SUNDRY NOTICES AND REPORTS ON WELLS (DO NOT USE THIS FORM FOR PROPOSALS TO DRILL OR TO DEEPEN OR PLUG BACK TO A DIFFERENT RESERVOIR. USE "APPLICATION FOR PERMIT" (FORM C-101) FOR SUCH PROPOSALS.) 1. Type of Well: Oil Well ☐ Gas Well ☐ Other INJ		WELL API NO. 30-025-05648
2. Name of Operator Apache Corporation		5. Indicate Type of Lease STATE ☒ FEE ☐
3. Address of Operator 303 Veteran's Airpark Lane, Suite 1000, Midland, TX 79705		6. State Oil & Gas Lease No. A-1543-1
4. Well Location Unit Letter O : 660 feet from the SOUTH line and 1980 feet from the EAST line Section 19 Township 19S Range 37E NMPM County Lea		7. Lease Name or Unit Agreement Name North Monument G/SA Unit [302708]
		8. Well Number #015 (515W)
		9. OGRID Number #873
		10. Pool name or Wildcat Eunice Monument; Grayburg-San Andres (23000)
11. Elevation (Show whether DR, RKB, RT, GR, etc.) 3657' GL

Well Name: NORTH MONUMENT G/SA UNIT #0515

Current and Proposed WBD

Action 445922

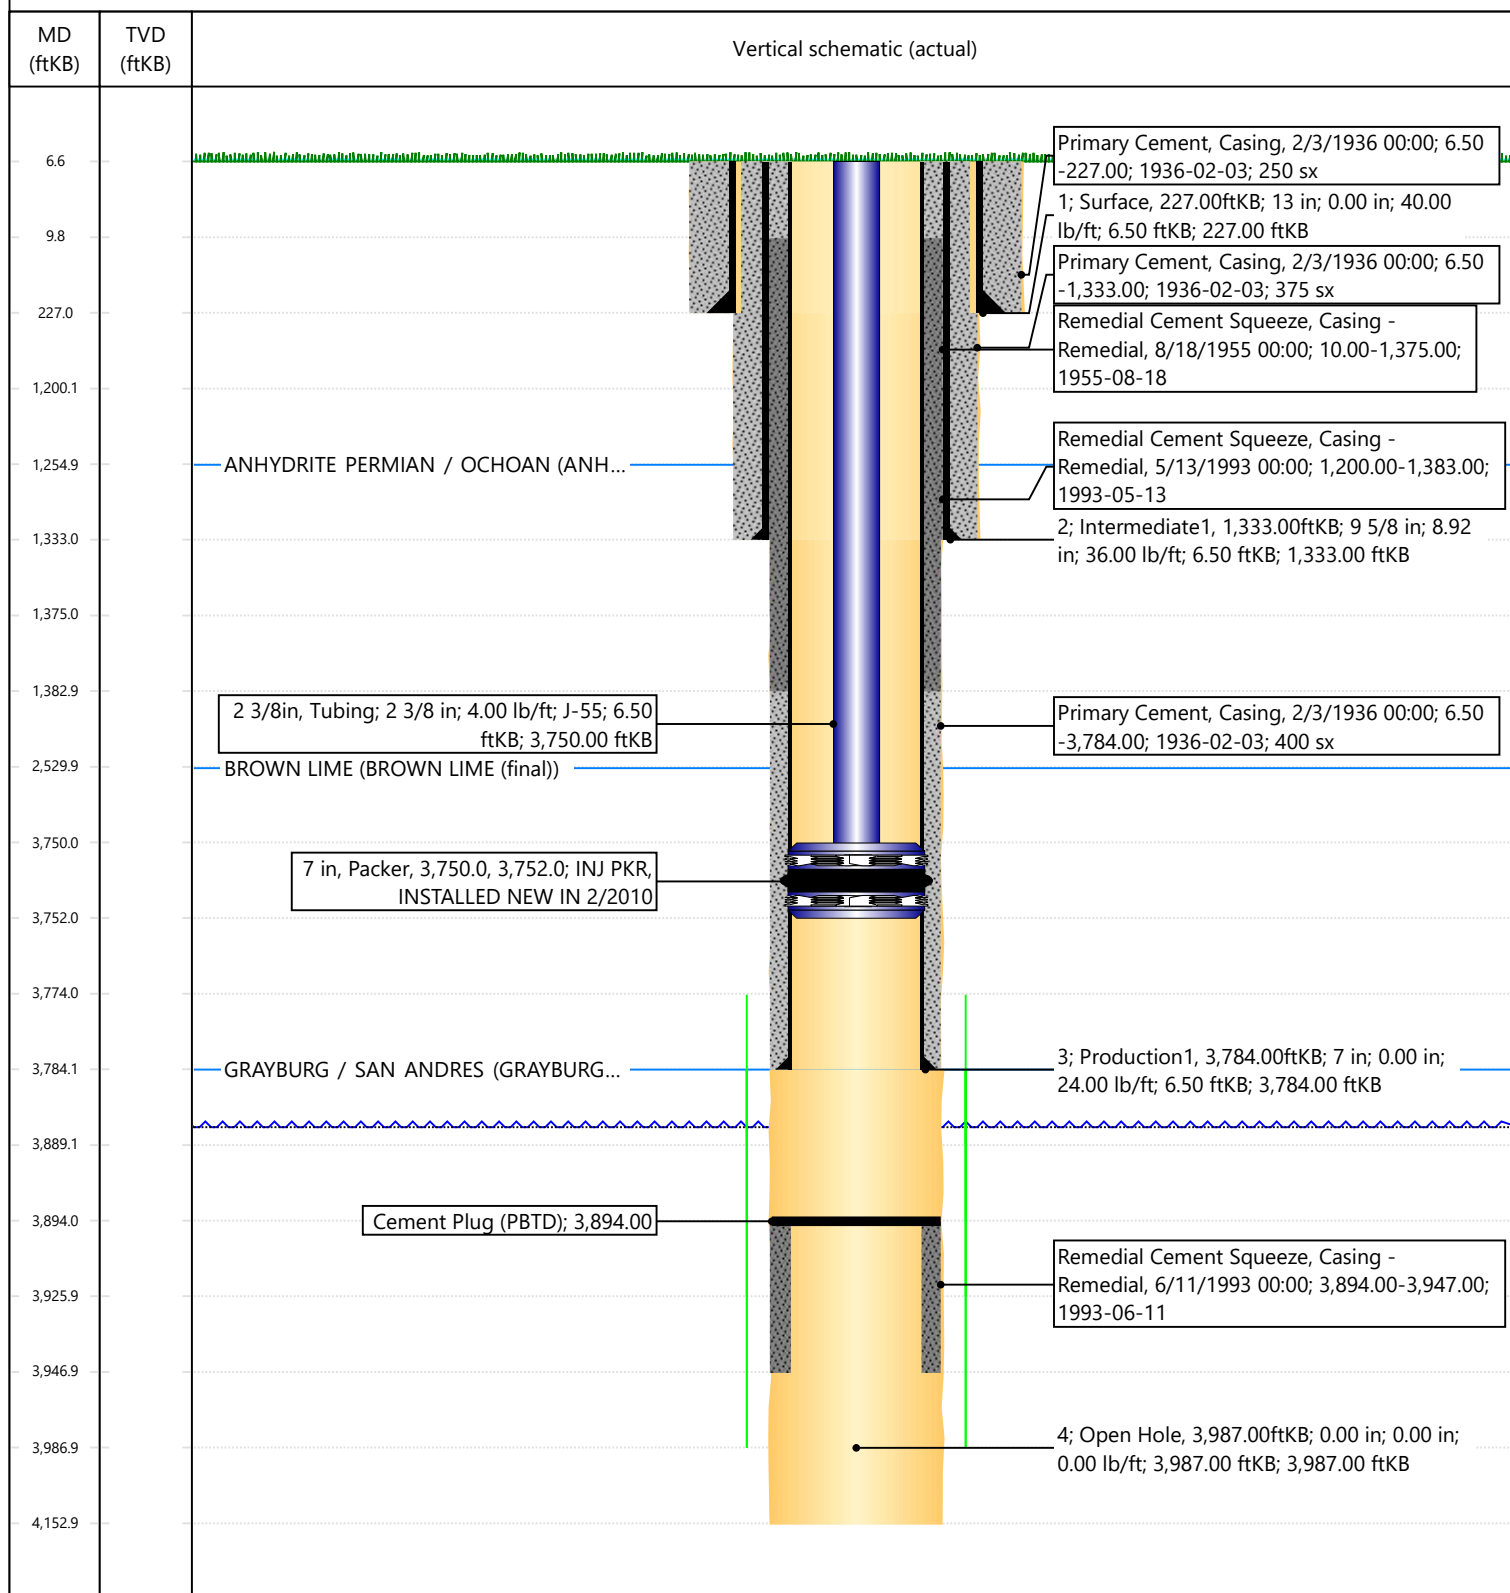
Created By	Condition	Condition Date
mgebremichael	Should the workover require tubing replacement, the same tube size stipulated in the respective order shall be replaced. The packer shall not be set more than 100 ft above the injection interval.	6/24/2025
